TE Connectivity

Product Change Notification: PCN-22-132592

General Product Description:
FRONT TPA RECEPTACLE

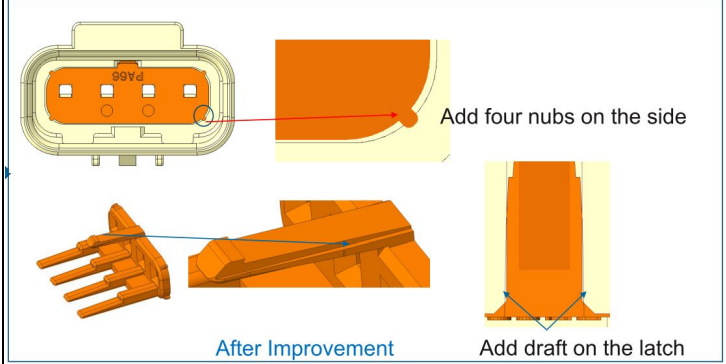
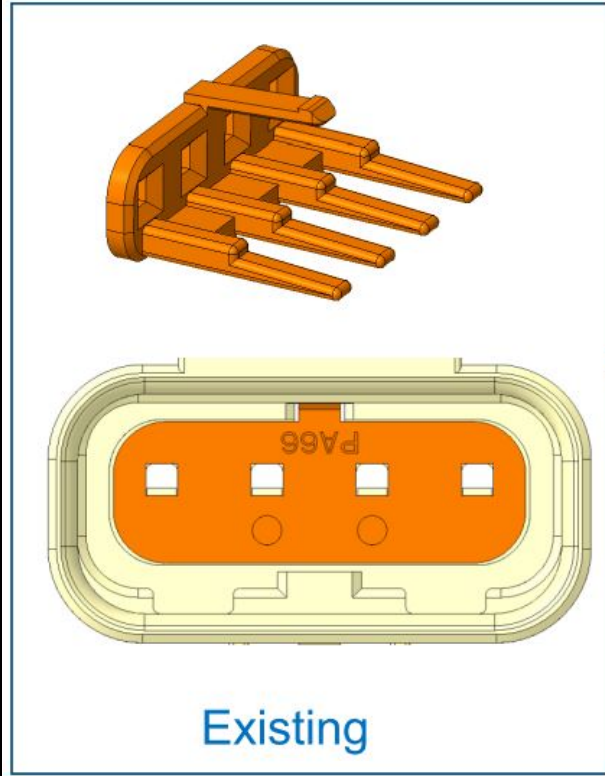
Description of Changes
Please be aware of an upcoming feature change to the listed part numbers. Before: SDL2.5 TPA fall off from the cap housing during the transportation. After: No TPA fall off during the transportation. Reference performance test data: Parts cleared Drop test requirement.

- The TPA for SDL 2.5 water proof connector. It is loaded from the front side of cap housing.
- Due to size limitation, current TPA is weak and the overlap between TPA lock and cap housing is only 0.1mm.

- To increase the retention between TPA and housing, propose to add nubs on the sides and add draft on the TPA latch.
- Tooling modification on 1 cavity for verification.
